AGENDA
HAILEY PLANNING & ZONING COMMISSION
Monday, December 8th, 2014
Hailey City Hall
5:30 p.m.

NB 1 Consideration of a Design Review application by Hailey Ice Inc., represented by Michael Bulls of Ruscitto/Latham/Blanton, for Design Review of a newly constructed indoor ice rink to be located within the Hailey Townsite, Lots 22-24 of Block 126, Lots 10-12 and 20-22 of Block 127, Lots 13-17 of Block 135 and all Lots within Block 134 (771 Main Street South), within the Limited Business (LB) and Townsite Overlay (TO) Zoning Districts.

TO: Hailey Planning and Zoning Commission
FROM: Micah Austin, Community Development Director
RE: Champion Ice House, Hailey Ice Rink Facility
HEARING: December 8, 2014

LANDSCAPE PLAN

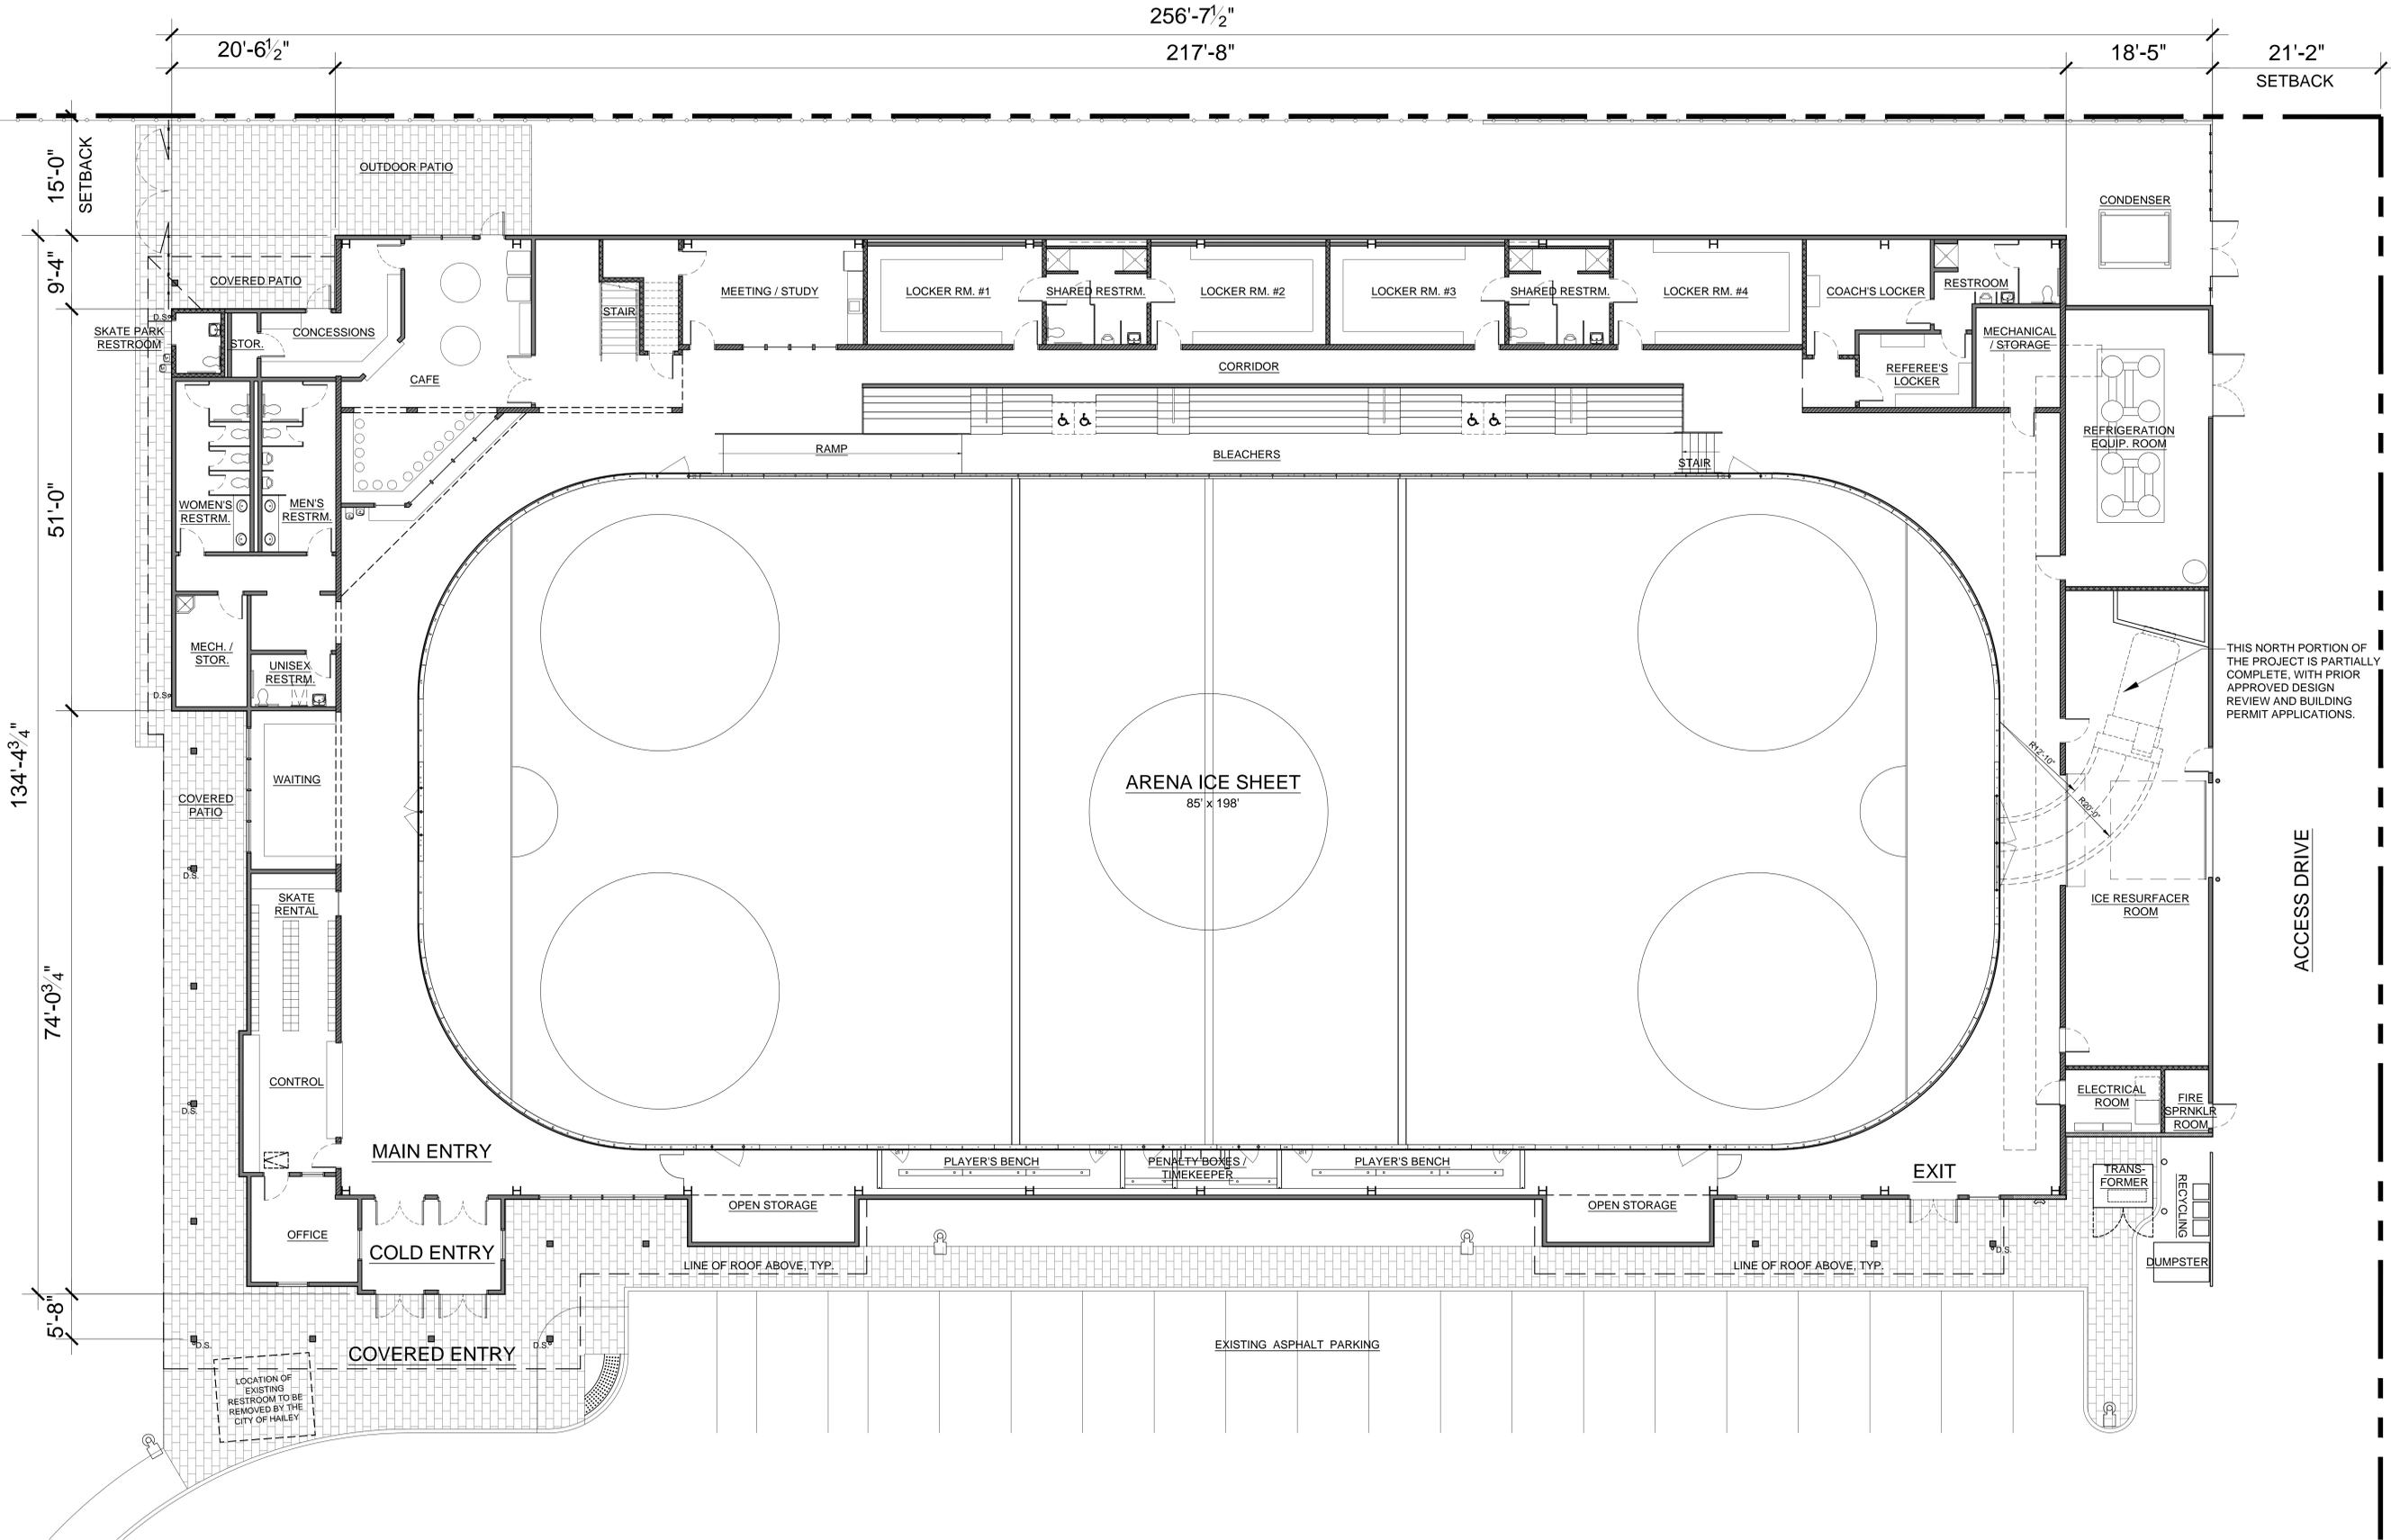
| | | | <i>Staff Comments</i> | - The condenser for the ice plant building will be screened with three evergreen trees shown on the Landscape Plan. - The electrical transformer and dumpster will be screened by a 5' tall wall clad with metal siding to match the building materials. |

| Compliant | | | Standards and Staff Comments | |
|-------------------------------------|--------------------------|--------------------------|------------------------------|--|
| | | | <i>Staff Comments</i> | - Drought tolerant plant species as specified by the Hailey Landscaping Manual as indicated on the Landscape Plan. |
| | | | <i>Staff Comments</i> | - The Landscape Plan specifies plantings that are hardy to the Zone 4 environment and located in the Hailey Landscape Manual. |
| | | | <i>Staff Comments</i> | - An irrigation system will be installed with a moisture sensor for all proposed plantings. - Low maintenance grasses are indicated on the west portion of the project and will be provided with temporary irrigation until they are established. - The turf grass landscaping on the south side of the project adjacent to the Skate Park areas will be repaired, patched, and reseeded where necessary to blend with the existing Skate Park area. - Irrigation for this area will be provided from the Skate Park area zone. |

| | | | <i>Staff Comments</i> | <i>- A combination of trees, low maintenance grasses, and ornamental grasses are specified on the Landscape Plan.</i> |
| | | | <i>Staff Comments</i> | <i>- The Landscape Plan specifies plantings that are hardy to the Zone 4 environment and located in the Hailey Landscape Manual. Refer Sheet L-1</i> |

30,971 SQ.FT. **MAIN LEVEL FLOOR PLAN**

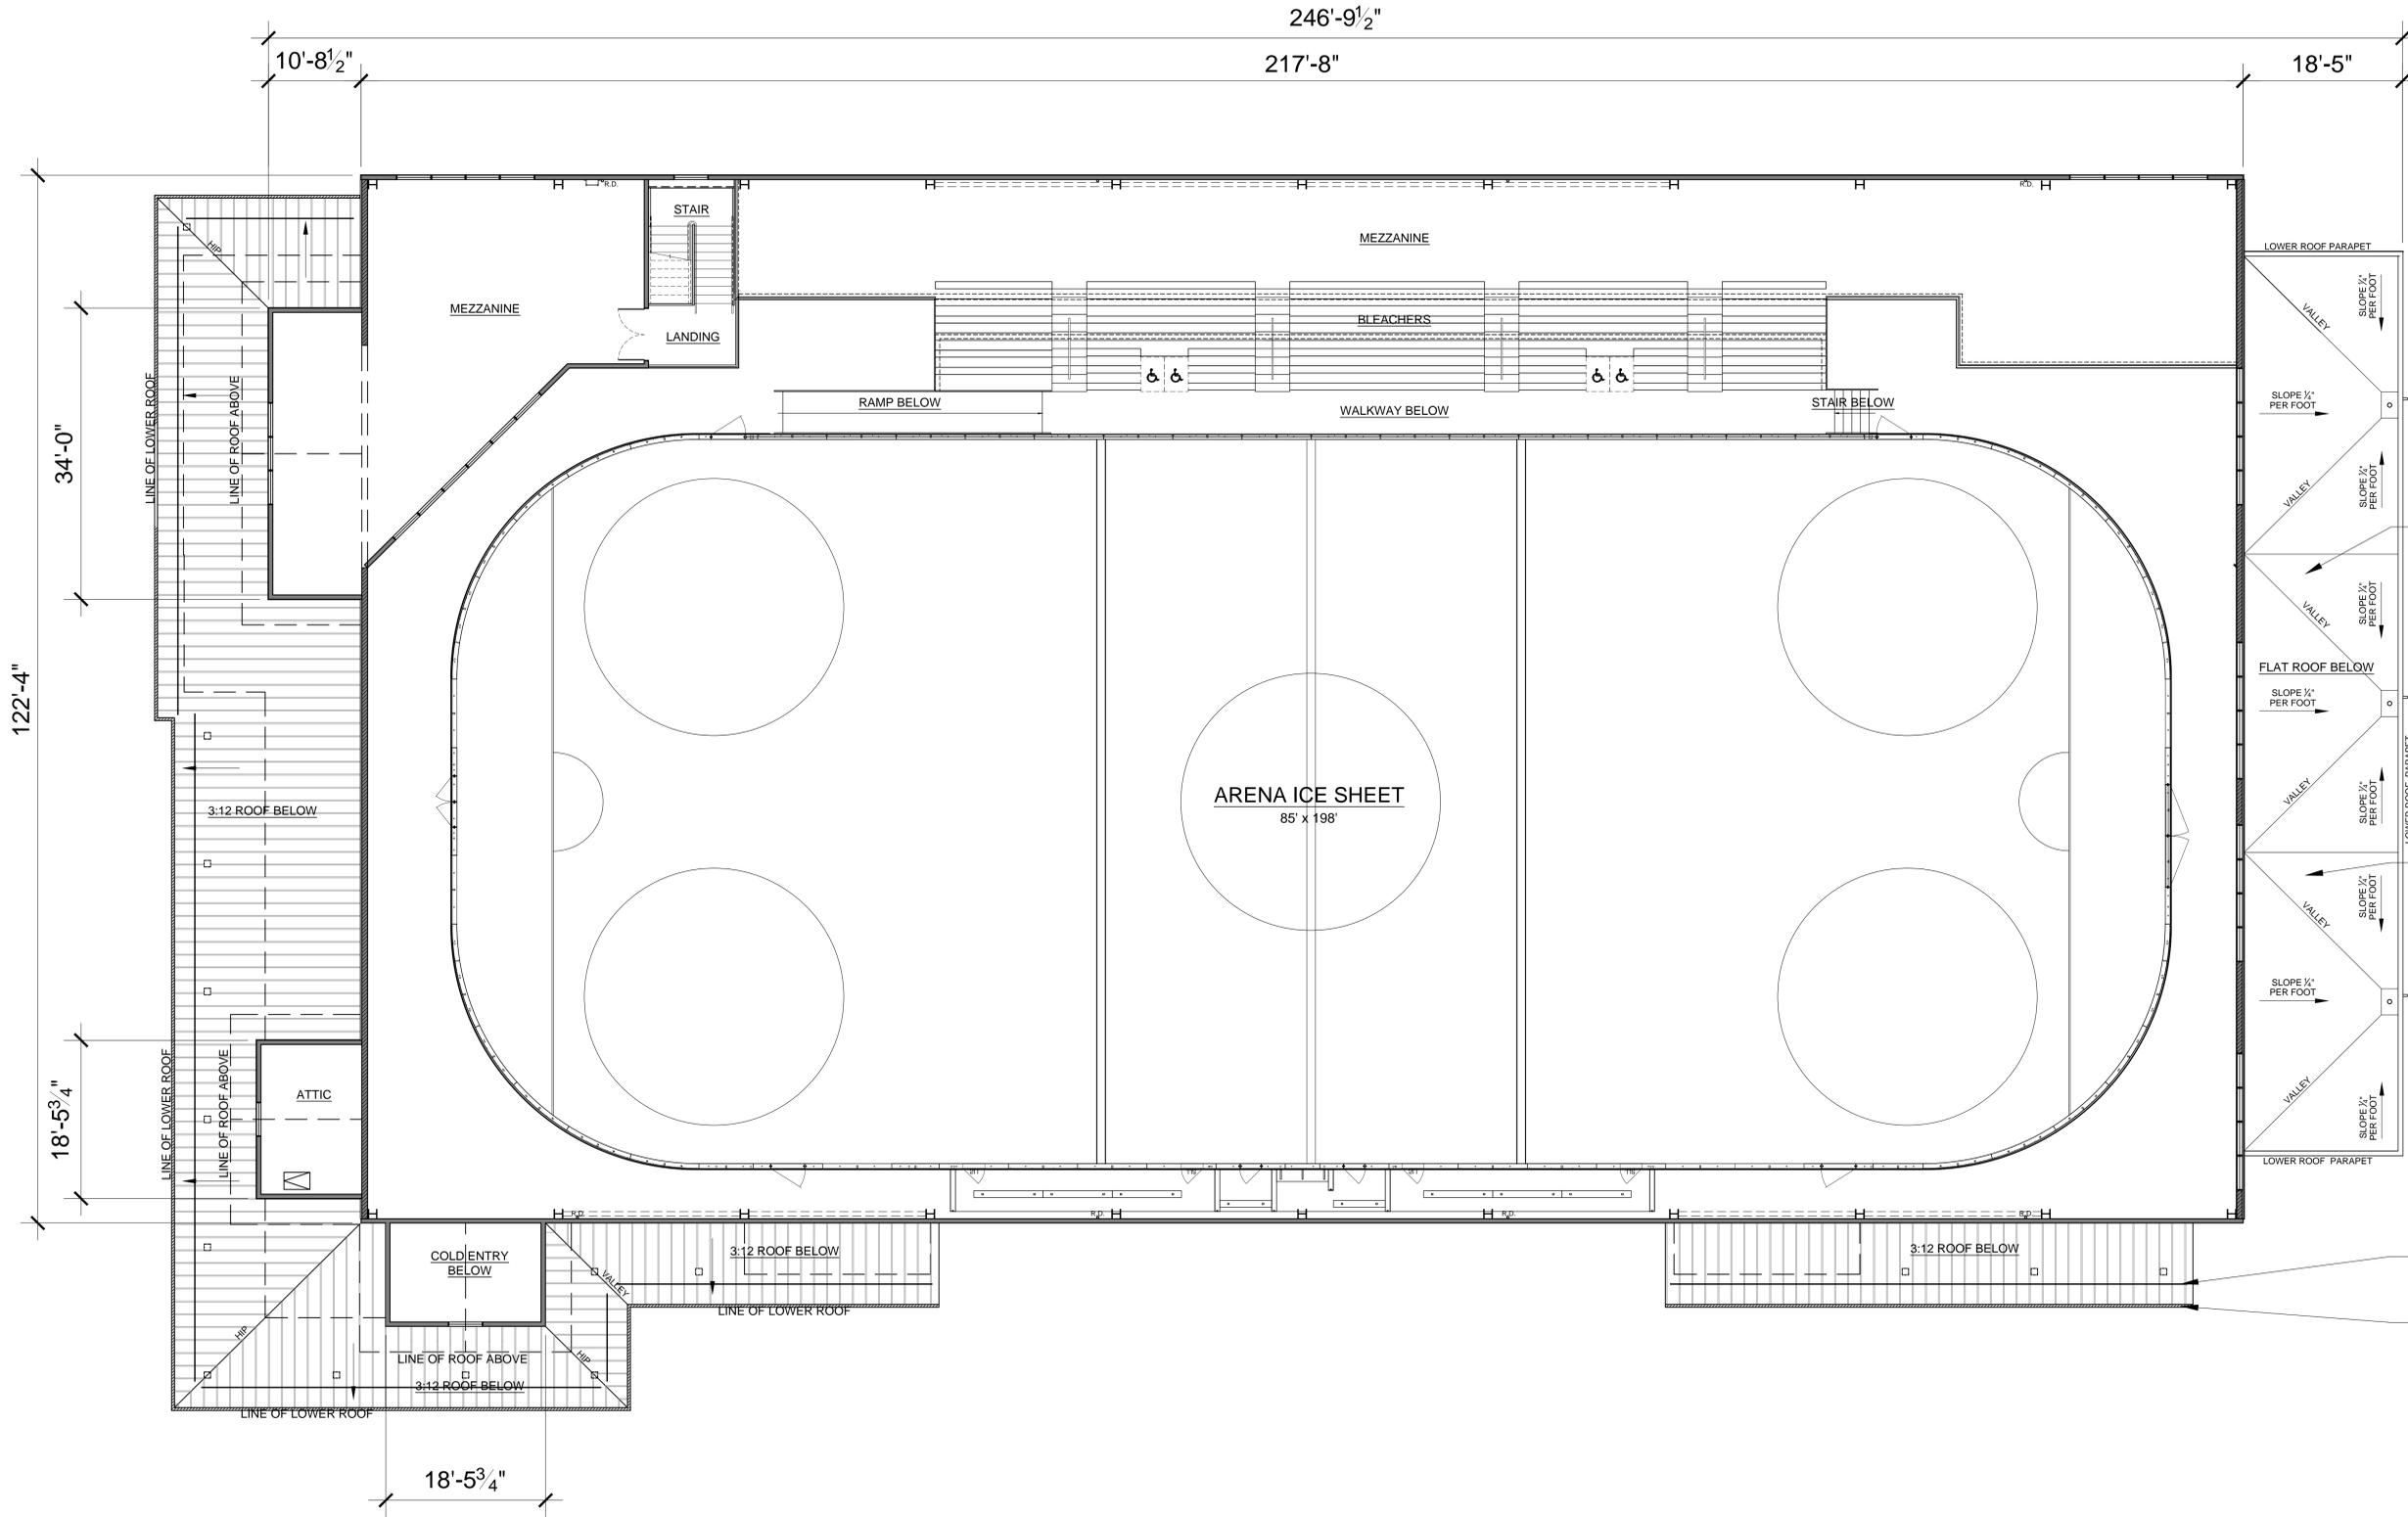
| General Requirements for all Design Review Applications | | | | |
|--|--------------------------|--------------------------|---|--|
| | | | | Building: - The City’s Plan Reviewer, Arlan Smith, requires an elevator to the second floor mezzanine, per 2010 ADA requirements, unless the architect can prove otherwise that an elevator is not required. |

- j) *An elevator is required for access to the second floor mezzanine or an explanation, signed and stamped by a licensed Idaho architect, on why an elevator is not necessary. This must be completed prior to issuance of the Certificate of Occupancy.*

NORTH ELEVATION - LOOKING SOUTH

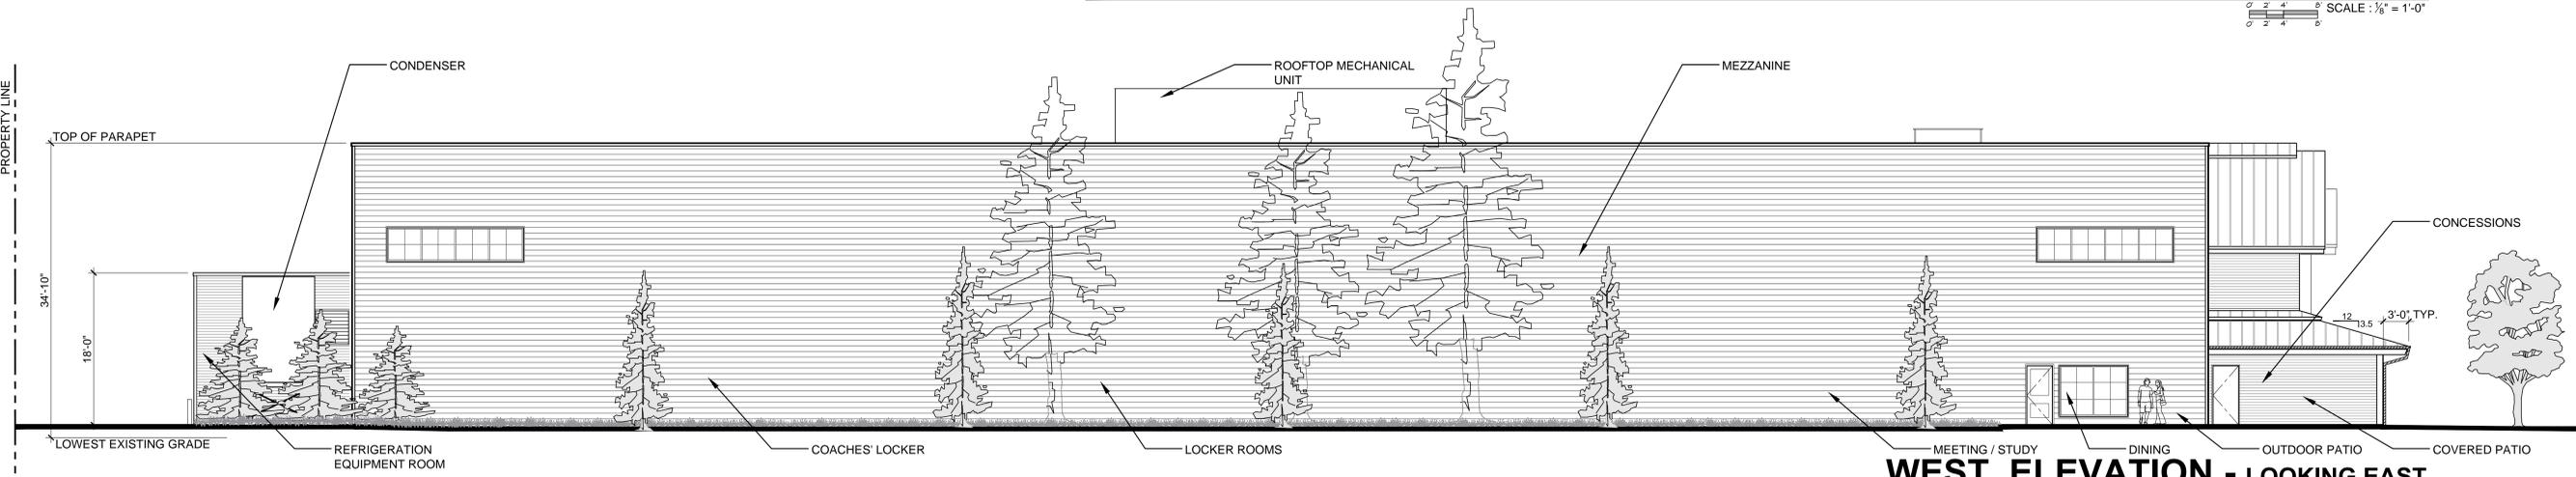
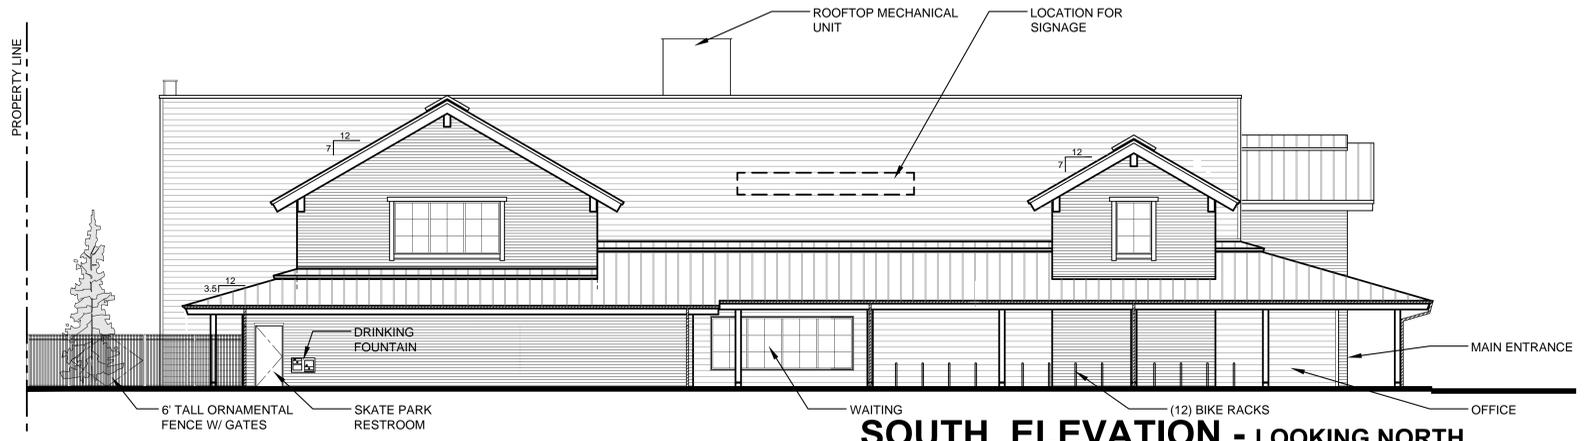
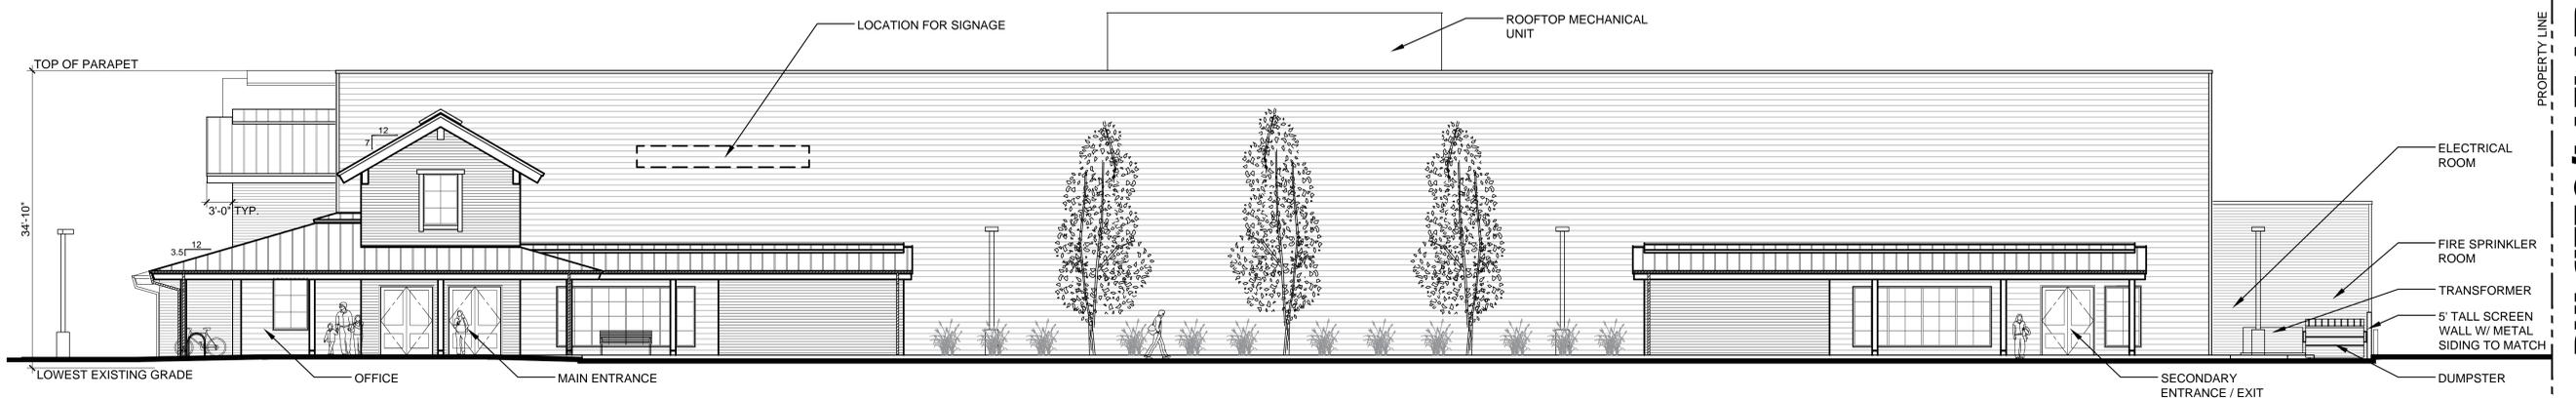
| | | | <i>Staff Comments</i> | <p>- All proposed buildings will be clad with metal siding with two different profiles to provide varying texture; box rib and corrugated metal siding. -Three complimentary colors are used. -The metal window and door finishes are compatible with the adjacent exterior materials.</p> |

| | | | <i>Staff Comments</i> | - No pop-outs are utilized to break up longer wall planes. |
| | | | <i>Staff Comments</i> | - Horizontal larger scale box rib metal siding is proposed on the large portion of the building that encloses the ice rink to emphasize its length and de-emphasize its height. - The wall is broken up with porch roofs and entrances. - While the current design may technically meet the standards of Design Review, staff has recommended that the applicant utilize a change of color or material on the west and east walls to reduce the perceived mass and scale of the building. |
